**CITY OF LA VISTA**  
**MAYOR AND CITY COUNCIL REPORT**  
**AUGUST 1, 2023 AGENDA**

| <b>Subject:</b>                                                    | <b>Type:</b>                              | <b>Submitted By:</b>                                            |
|--------------------------------------------------------------------|-------------------------------------------|-----------------------------------------------------------------|
| CONDITIONAL USE PERMIT –<br>LOT 2 SOUTHPORT EAST<br>REPLAT FIFTEEN | ◆ RESOLUTION<br>ORDINANCE<br>RECEIVE/FILE | CHRISTOPHER SOLBERG<br>DEPUTY COMMUNITY<br>DEVELOPMENT DIRECTOR |

RE: REV Development – PUD, CUP & Replat Applications – Initial Review Letter  
Lots 5-6 Southport East

RE: Southport East - Port Grace & 123rd Landscape Review - Design Review Letter #1

## LANDSCAPE PLAN

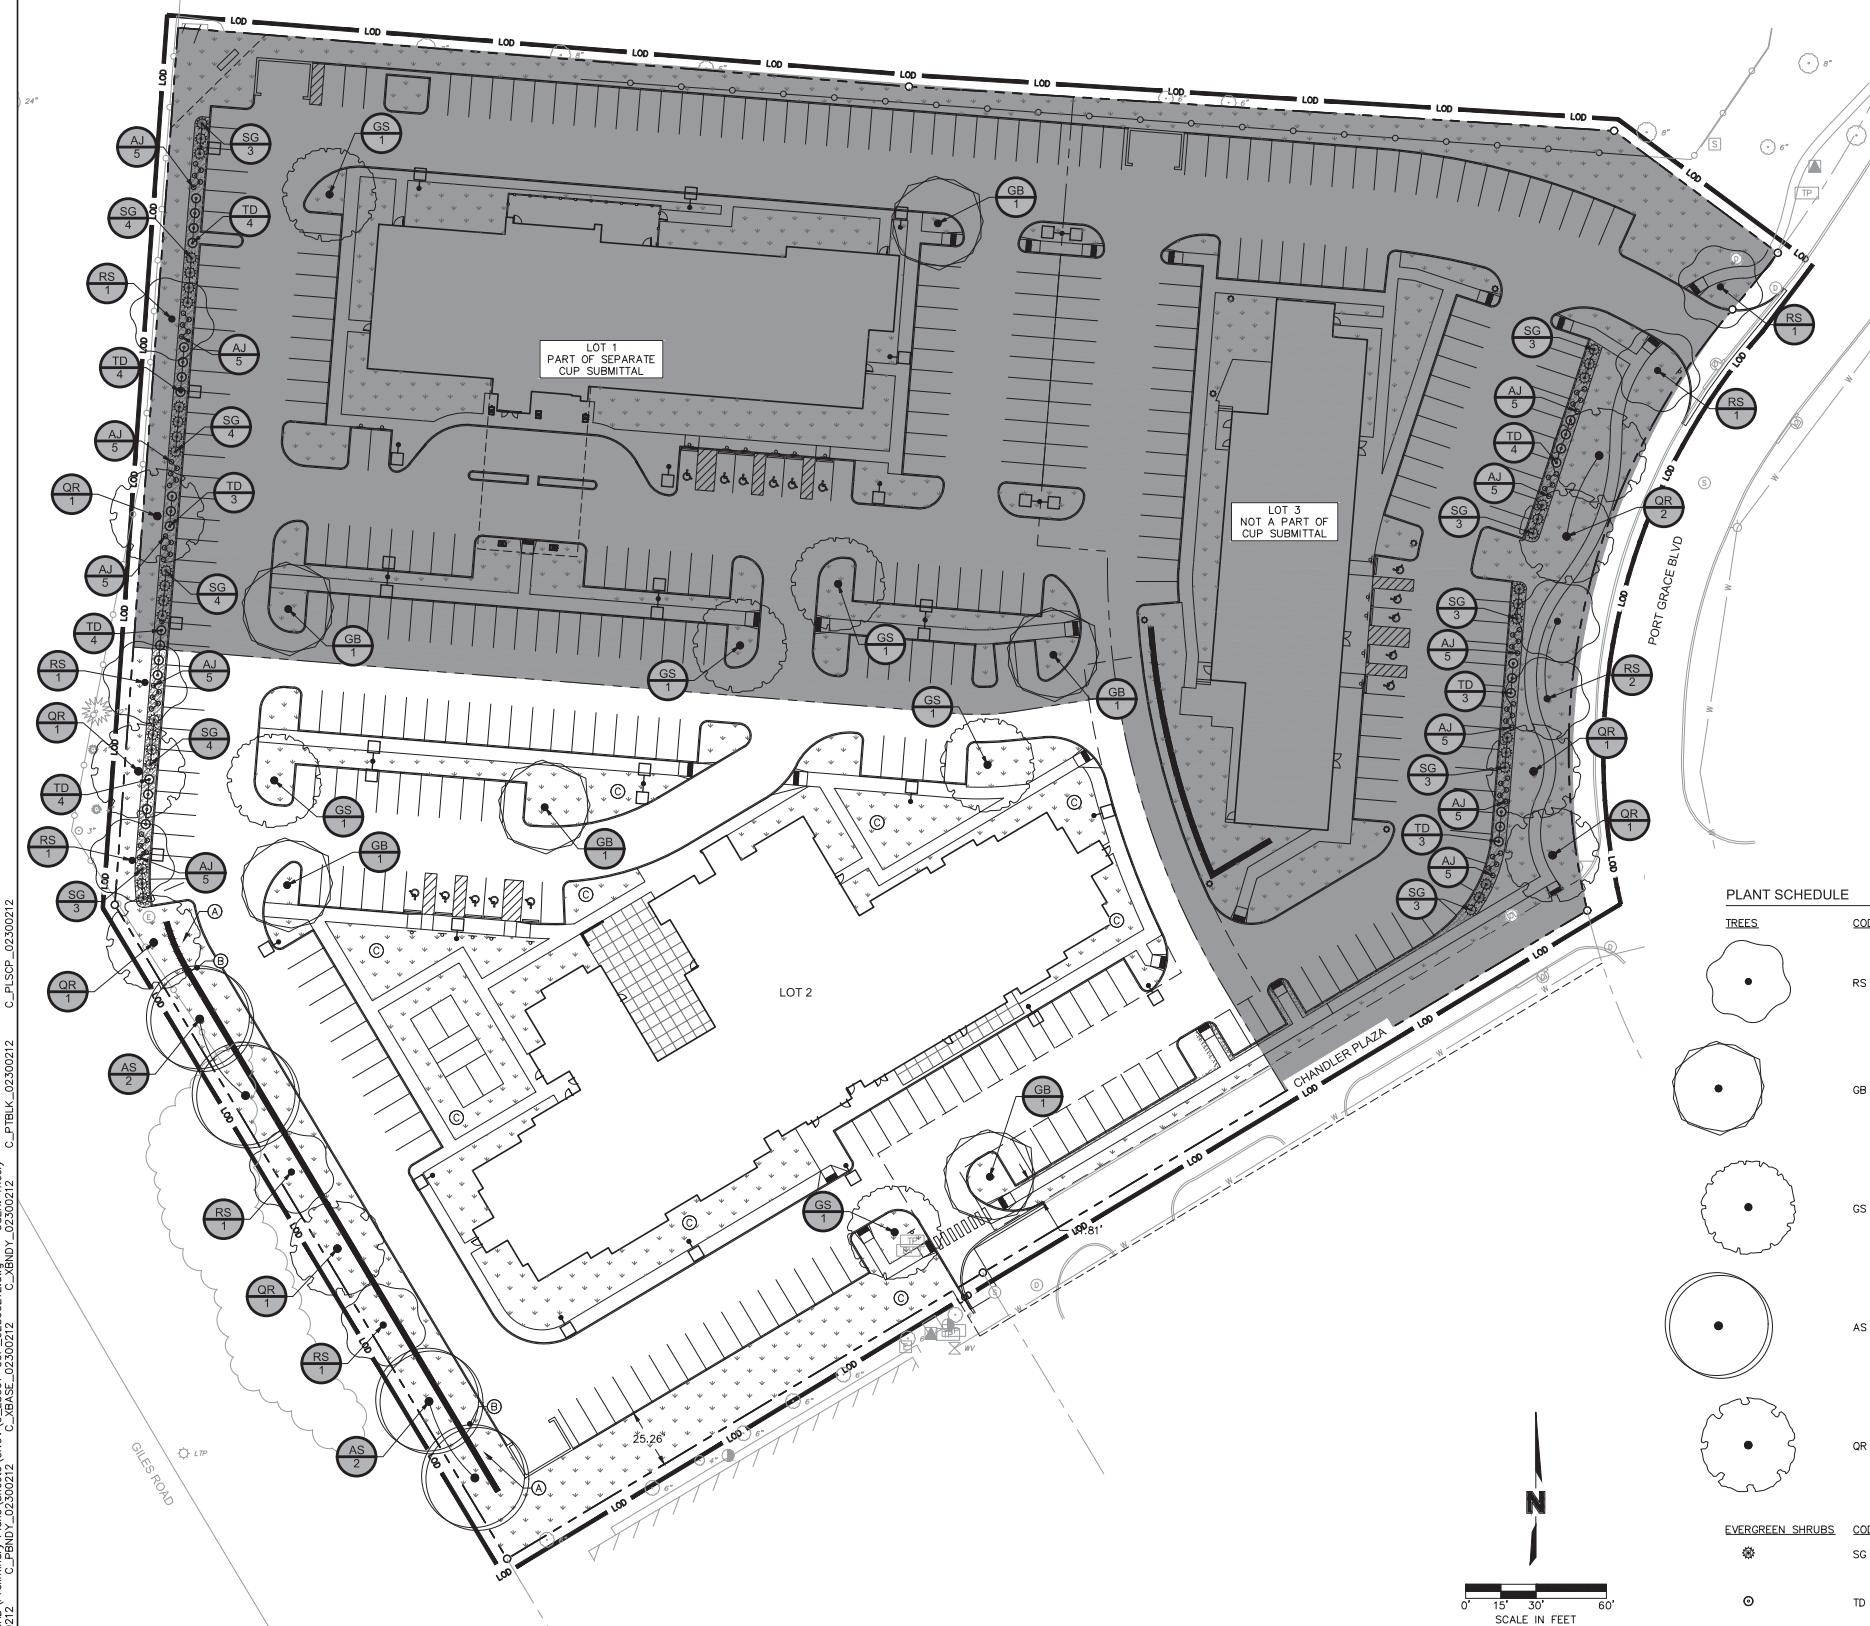
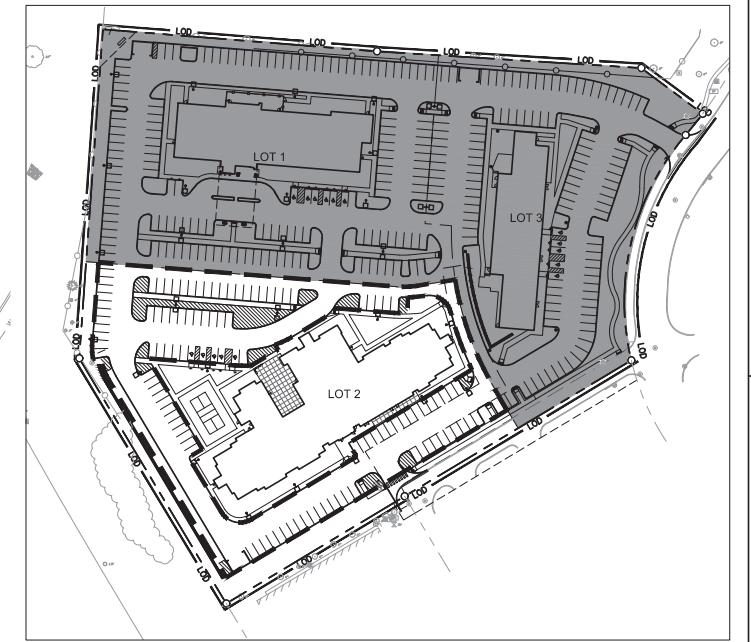
1. Landscaping
  - i. No site dimensions are included to determine compliance with 6.1.D, which requires ten (10) foot wide landscaped, turfed (sodded or seeded) and irrigated green space along all interior lot lines shown in Appendix E.
  - ii. Per appendix G, the following proposed plants are not included in the approved list:
    1. Autumn Blaze Maple
    2. Bloodgood London Plane Tree
    3. Silver Linden
    4. Maney Juniper
    5. Karl Foerster Feather Reed GrassRevise to comply with Appendix G.
  - iii. Per Appendix G, trees shall have a minimum caliper of 3". Trees proposed on plant schedule have a caliper ranging from 2 to 2.5". Revise to comply with Appendix G.
